GFA AIRWORTHINESS DIRECTIVE

TYPE AFFECTED: H-205 Club Libelle;
H-206 Hornet and Hornet C

SUBJECT: Rudder gimbal drive, rear actuator arm.

**Airworthiness
Directive
2003-004**

203-45-10-2

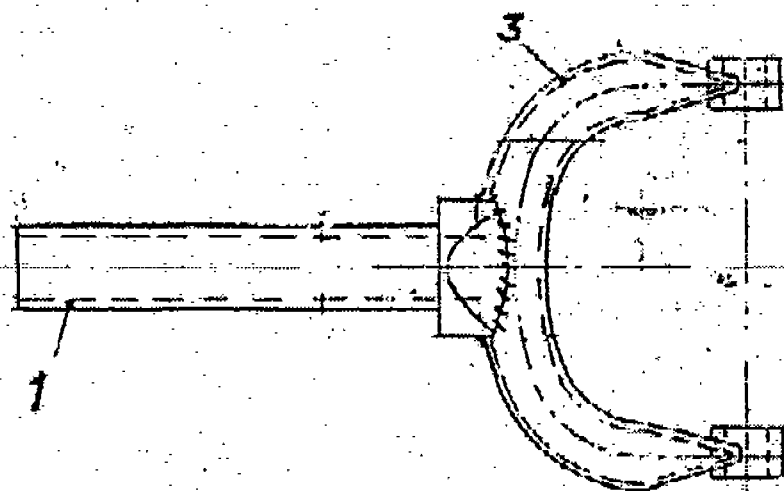
ACTION REQUIRED: Replace actuator arm with improved item.

Exchange of an improved actuator arm.

- 1 off rudder actuator arm made according to drawing 203-45-10-2
1 off M4 stop nut
3 off Split pins, 1.5 x 18 mm

Replacing the actuator arm must be done by Hansjörg Streifeneder Glasfaser-Flugzeug-Service GmbH only or by an approved repair station.
Only genuine parts made in accordance with drawing No. 203-45-10-2 must be used.
Proper accomplishment of the action must be entered into the sailplane log book by a licensed inspector.

Im WIG-Verfahren mit Zusatzwerkstoff 1.7734.2 geschweißt. Grundiert mit Wash-Primer 42002 + Härter 40018. Decklackierung mit Nitro-Lack schwarz 43002.

Spannungsfrei gegläht
bei 580°C 4 std.
unter Schutzgas
